# WATER QUALITY MEMORANDUM

## Utah Coal Regulatory Program

RE: 2008 3rd Quarter Water Monitoring, Consolidation Coal Company, LLC,  
Emery Deep Mine, C/015/0015, WQ08-3, Task ID #3155

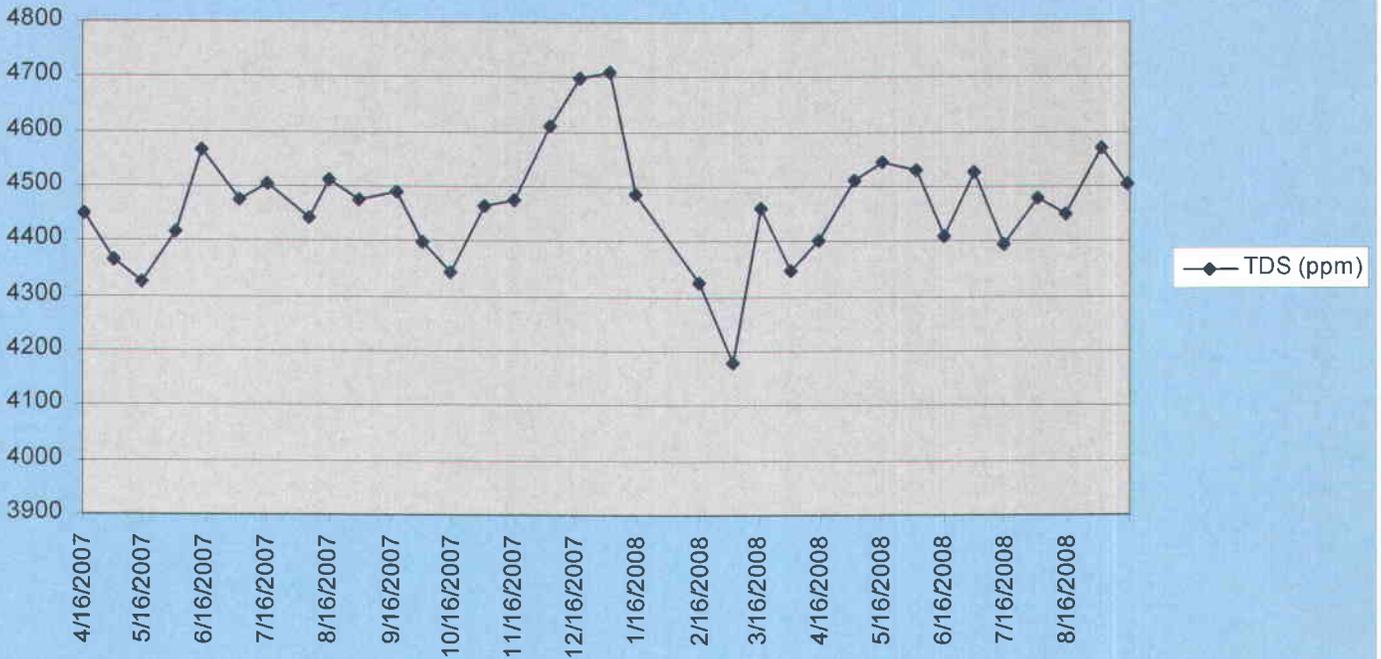
As outlined in the Permittee's Utah Pollutant Discharge Elimination System permit (UPDES), the effluent limitation for Total Dissolved Solids is 3,500-ppm. However, the reported TDS values for outfalls 001 and 003 have exceeded that limit for several years. Based upon six sampling events during this quarter, Outfalls 001 and 003 reported average TDS values of 4,486-ppm and 3,975-ppm respectively. (See Attached Charts)
